HISTORIC AND DESIGN REVIEW COMMISSION

HDRC CASE NO: 2021-608

ADDRESS: 116 CAMARGO

TYPE OF WORK: Partial demolition of a rear accessory structure

10. HEAD & SILL DET at TYP WIN SCALE: 3" = 1'-0"

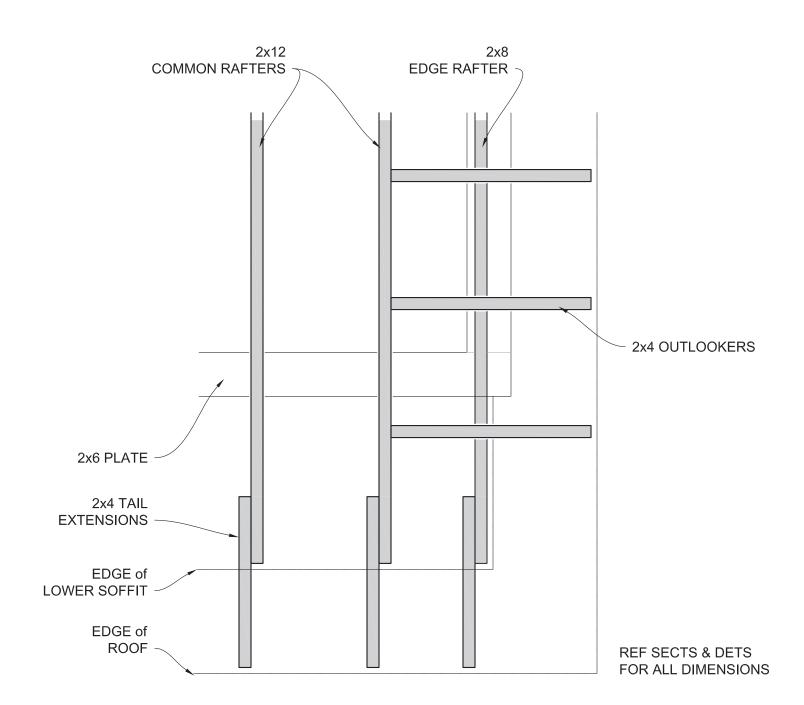
- 2f. MATERIALS: DOORS AND WINDOWS The applicant has proposed to install fully wood, full-lite French doors with transom windows on the north façade, one two-over-two aluminum-clad wood or fully wood window and a high horizontal vinyl window on the south elevation. The aluminum-clad or fully wood windows should feature an inset of two (2) inches within facades and should feature profiles that are found historically within the immediate vicinity. An alternative window material may be proposed, provided that the window features meeting rails that are no taller than 1.25" and stiles no wider than 2.25". White manufacturer's color is not allowed, and color selection must be presented to staff. There should be a minimum of two inches in depth between the front face of the window trim and the front face of the top window sash. This must be accomplished by recessing the window sufficiently within the opening or with the installation of additional window trim to add thickness. Window trim must feature traditional dimensions and an architecturally appropriate sill detail. Window track components must be painted to match the window trim or be concealed by a wood window screen set within the opening. Staff finds that vinyl windows are inappropriate and that all windows and doors should be fully wood or aluminum-clad wood windows. The applicant should submit final material specifications to staff for review and approval.

- i. That the applicant installs fully wood or aluminum-clad wood windows that meet staff's standard window specifications based on finding 2f. Wood or aluminum-clad wood windows are recommended and should feature an inset of two (2) inches within facades and should feature profiles that are found historically within the immediate vicinity. Meeting rails must be no taller than 1.25" and stiles no wider than 2.25". White manufacturer's color is not allowed, and color selection must be presented to staff. There should be a minimum of two inches in depth between the front face of the window trim and the front face of the top window sash. This must be accomplished by recessing the window sufficiently within the opening or with the installation of additional window trim to add thickness. Window trim must feature traditional dimensions and architecturally appropriate sill detail. Window track components must be painted to match the window trim or concealed by a wood window screen set within the opening. Final materials specifications must be submitted to staff for review and approval.

13. SOUTH ELEVATION

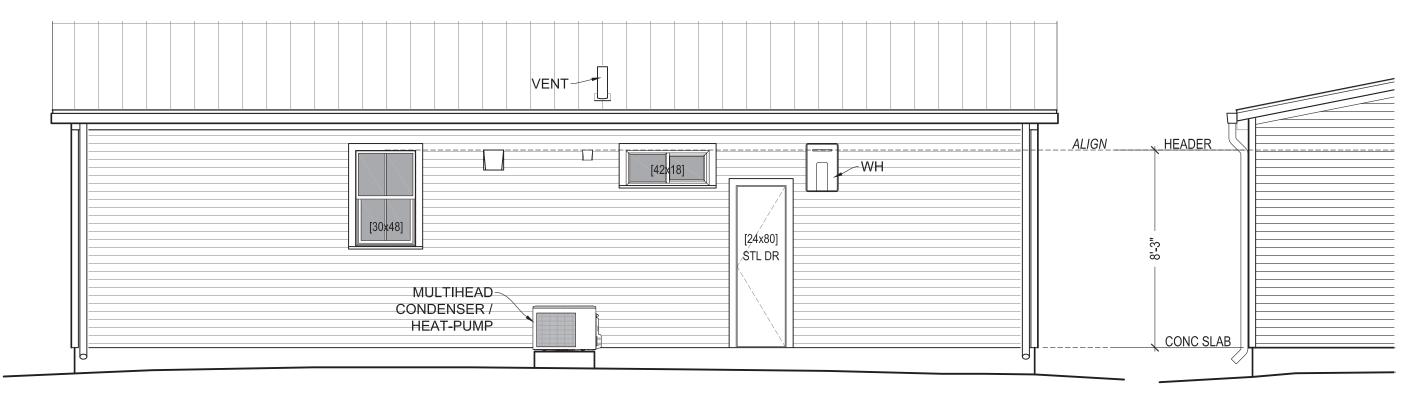
- 2g. WINDOWS AND DOORS: SIZE AND PROPORTION The applicant has proposed to install windows and doors with traditional proportions and one (1) high horizontal vinyl window on the south elevation. Guideline 2.C.i for New Construction states that applicants should incorporate window and door openings with a similar proportion of wall to window space as typical with nearby historic facades. Windows, doors, porches, entryways, dormers, bays, and pediments shall be considered similar if they are no larger than 25% in size and vary no more than 10% in height to width ratio from adjacent historic facades. Staff finds that the applicant should update the fenestration pattern on the south elevation to feature more traditional proportions.

- ii. That the applicant proposes a fenestration pattern and window opening proportions on the south elevation that are more consistent with the Guidelines and the Standard Specifications for Windows in Additions as noted in finding 2g. The applicant is required to submit updated elevation drawings showing traditional window proportions on the rear elevation to staff for review and approval prior to the issuance of a Certificate of Appropriateness.
